RE: Additional Information Request No. 2
Lyons Quarry, Permit No. M-1977-208
Y22Q1 Groundwater Monitoring Report, C-Pit

On June 6, 2022, CEMEX received a second letter from Division of Reclamation, Mining and Safety (DRMS) titled "AdditionalInfoNeeded_No2_M77208_1Q2022.pdf" related to our 2022 1st Quarter Groundwater Monitoring Report. Below are CEMEX's responses in *italic font* to the requested items 1 and 2:

Figure 9

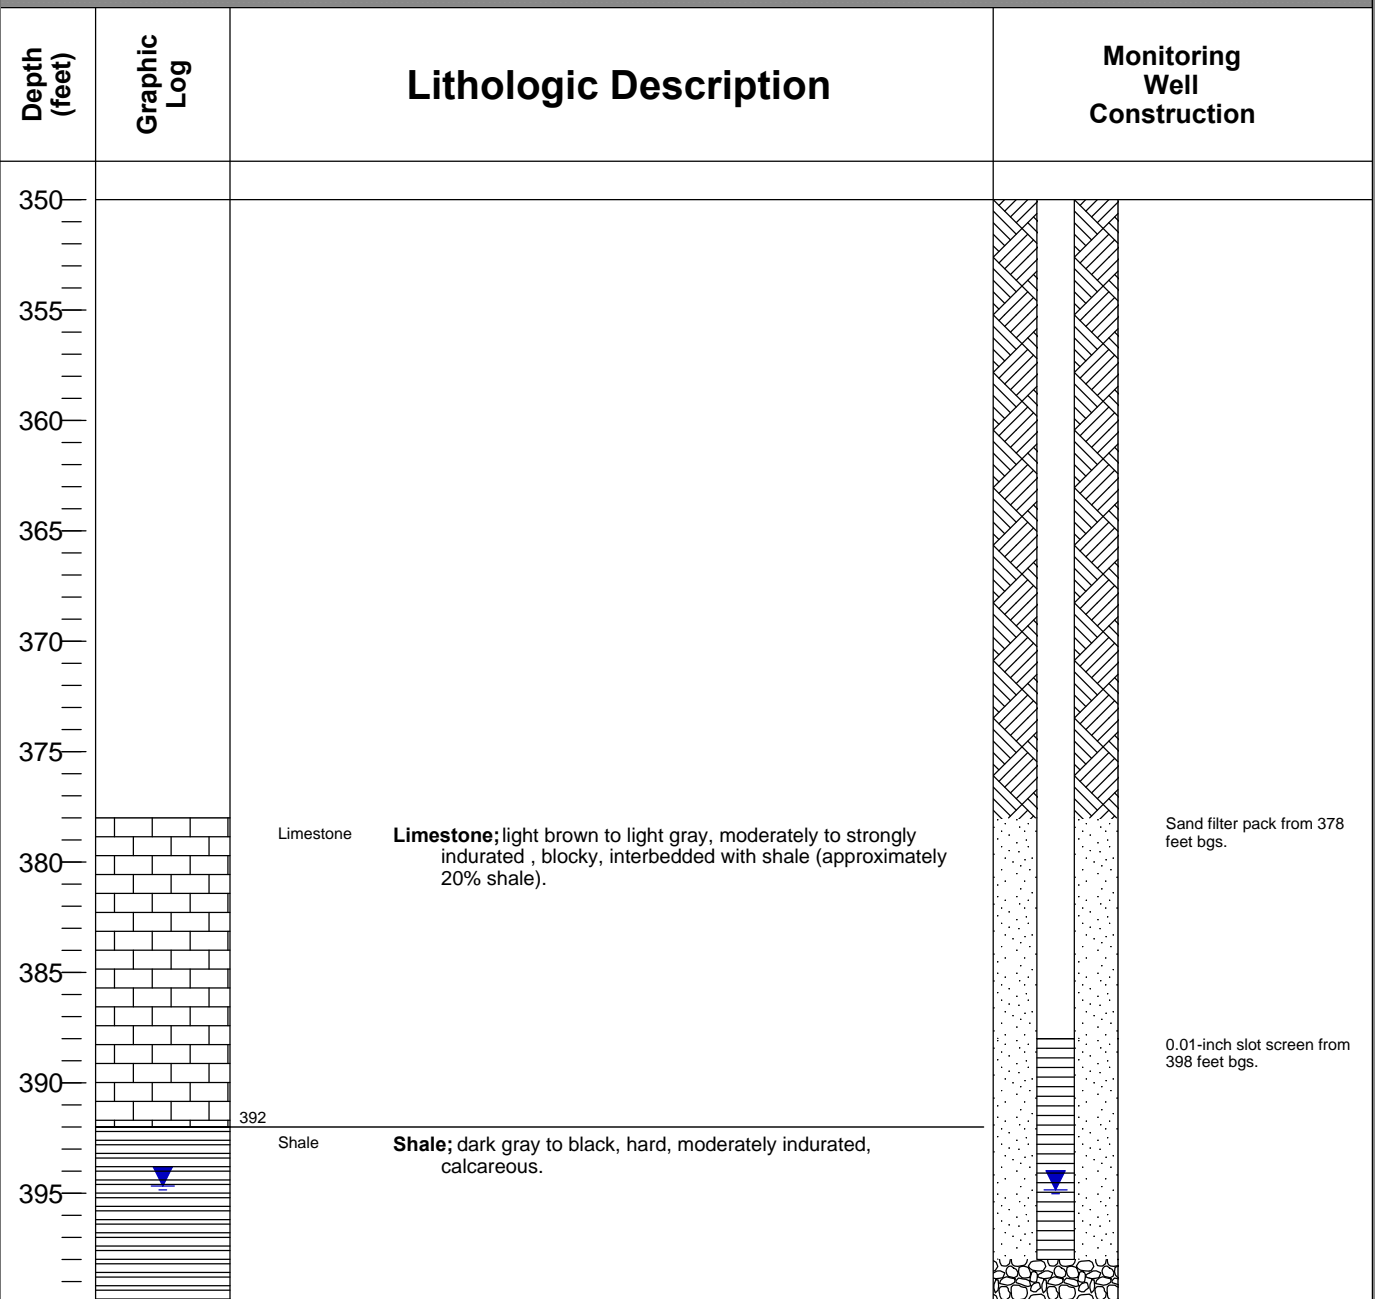
2. For CEM-005 the Operator stated water level detection and well purging occur during the quarterly monitoring but groundwater does not recharge in sufficient time to collect a sample. Please provide the field data sheet, forms, or other documentation that clearly demonstrates the well was monitored in first quarter 2022 as stated. Additionally, CEM-005 is a point-of-compliance well for the site. Has the Operator evaluated using other sampling methods, such as passive and no-purge sampling devices, to collect a sample from the well? It is incumbent upon the Operator to collect samples from the point-of-compliance well to document compliance and facilitate eventual release of the permit.

CEMEX has attached a PDF Excerpt of Technical Revision 8 (TR-8) for the CEMEX Lyons Quarry (M1977-208). This includes a description of the CEM-005 well including the Technical Boring Log. In addition, Field Notes from Q1 2022 have been included per the DRMS request.

The point-of-compliance well CEM-005 was sited and completed across both the Carlile Shale and Ft. Hayes Limestone formations with understanding and approval from DRMS. The bottom portion of the 0.01-inch slot well screen (approximately 10 feet in depth) is within the shale whereas the sand filter pack extends up into the limestone (approximately 10 feet above the top of the screen). As designed, the screen and sand pack monitor the Ft. Hays Limestone formation which, historically, has not produced sufficient water for sampling. Furthermore, additional language from TR-11 states the following:
